833-001-13

ADDENDUM NO. 1

IAC / GT Exhaust
 Lincoln, Nebraska
 TCEP No.: 833-001-13

Addendum #01
 Supplemental Drawing: SDS-001
 Revision of Sheet: S2.02
 Date: 11/15/13

12 MAKEUP AIR UNIT PAD DETAIL

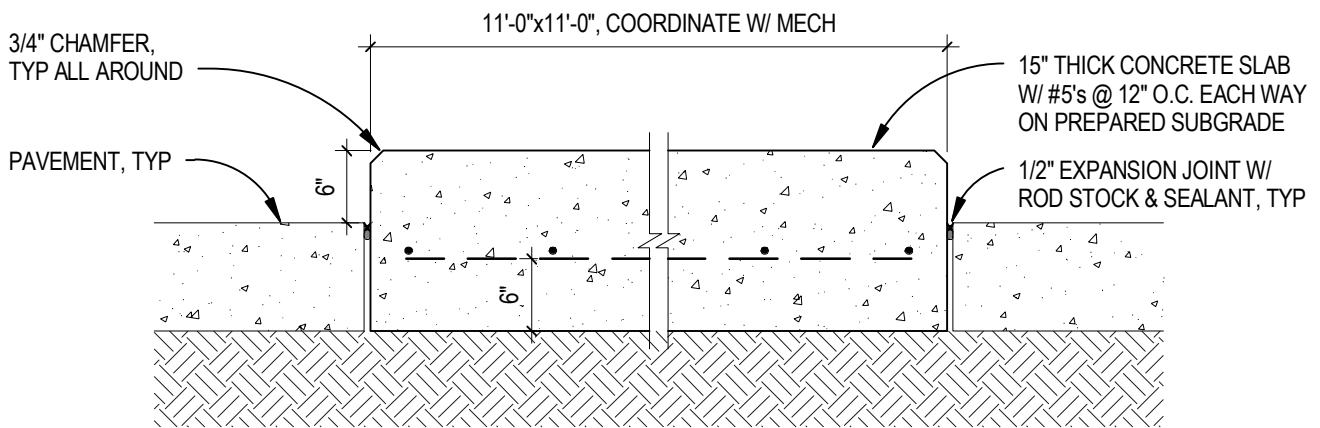
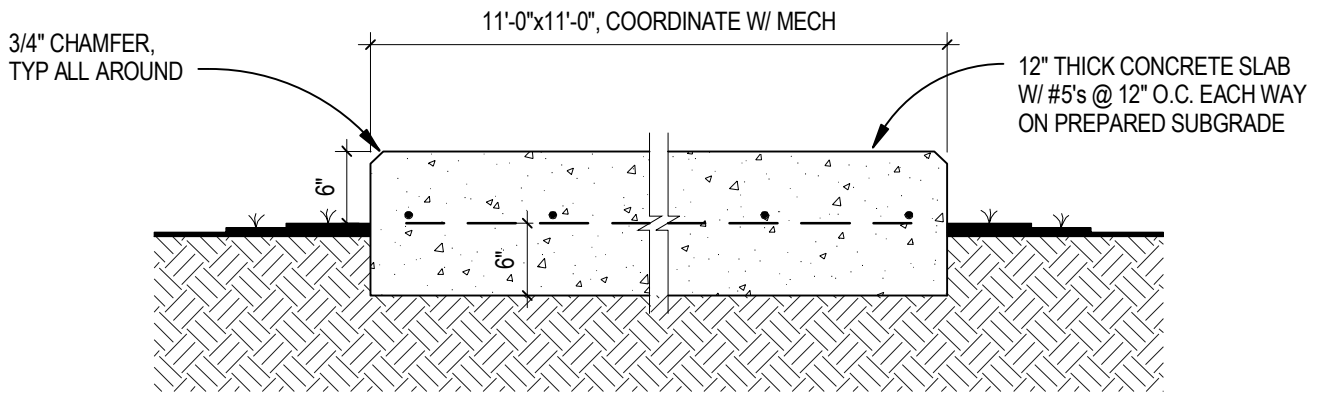
Item 1-14: Sheet S2.02 – Foundation Details

Add Detail 12 Makeup Air Unit Pad Detail, see attached Supplemental Drawing SDS-001.
